Draft State Environmental Planning Policy 65 and Draft Apartment Design Guideline raises fundamental issues about the NSW Planning System

Submission to the NSW Government on the draft State Environmental Planning Policy No 65 – Design Quality of Residential Flat Development and draft Apartment Design Guide.

d. Ceiling Heights

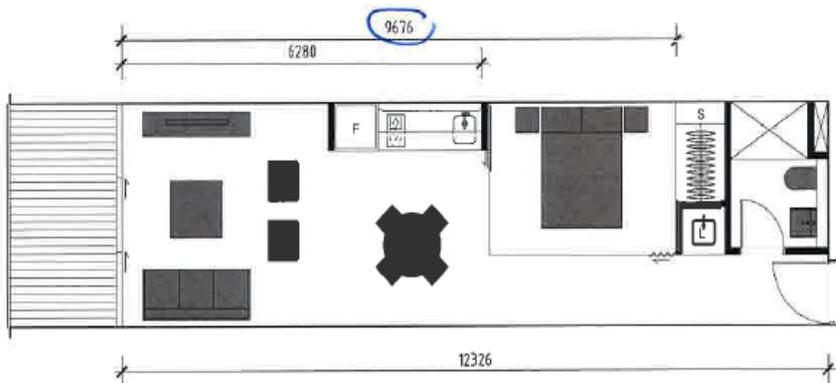
The flowing figures show standard apartments that are currently approved and built with a standard 2.7 floor to ceiling height. Applying the draft controls would mean that these apartments would not be approved unless the floor to ceiling height was significantly increased as indicated in red.

Ceiling height = 4.1m X

Ceiling height = 3.0m X

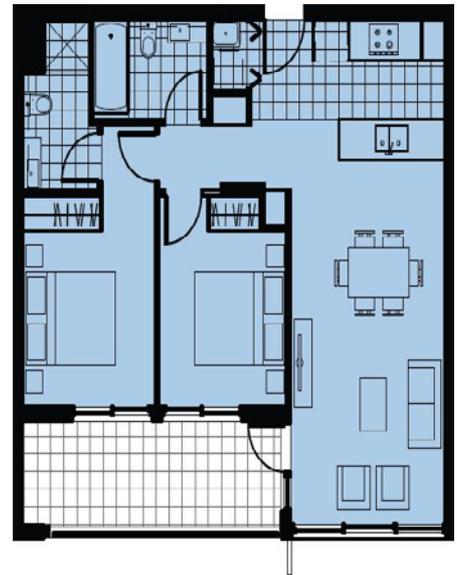
Views from living areas less than optimal. Consumers forced to accept this.

The figures above demonstrate the impact of regulation on built form outcome. To achieve the level of solar access required in living areas and private open space, the balcony must be set to the side of the living space at the expense of views and access.

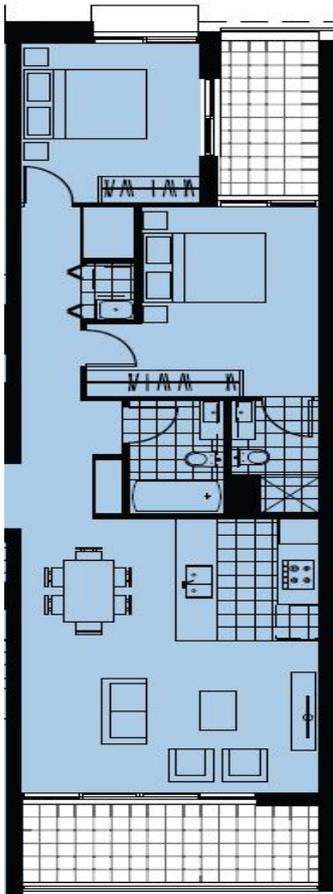
The figure below shows what the market really wants. This apartment layout provides much better outlook and amenity. While the indoor living area may not always achieve the required solar access, the balcony generally does. When asked, customers prefer less sun in living areas in return for sun on balconies and much improved outlook.

Consumers prefer this outlook

Consumers prefer this apartment layout where living areas open directly onto balcony. This layout is limited due to the requirement to achieve 3 hrs sun light on balcony and living areas.

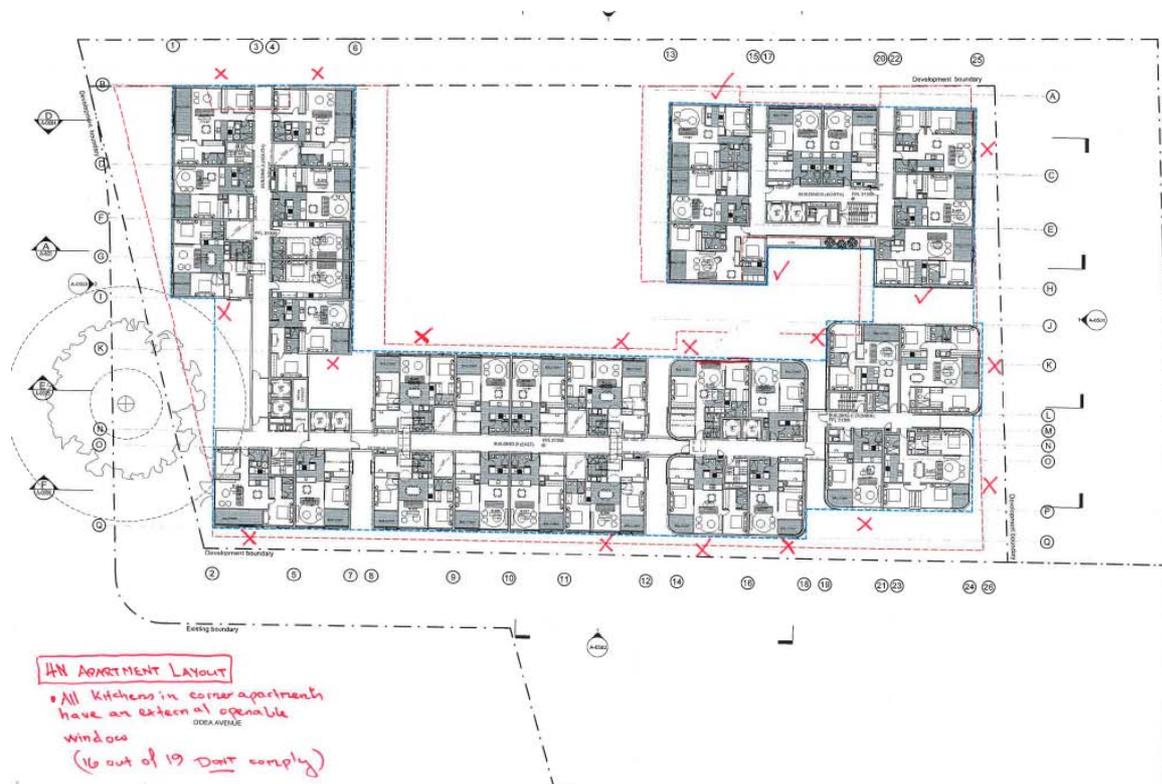
It is also concerning to note that the draft guide includes a number of indicative apartment layouts at section 4N (reproduced below). The apartments highlighted with the red bubble would find it difficult to achieve the required 3 hours sunlight into living rooms. However, they would achieve 3 hours sunlight to balconies.
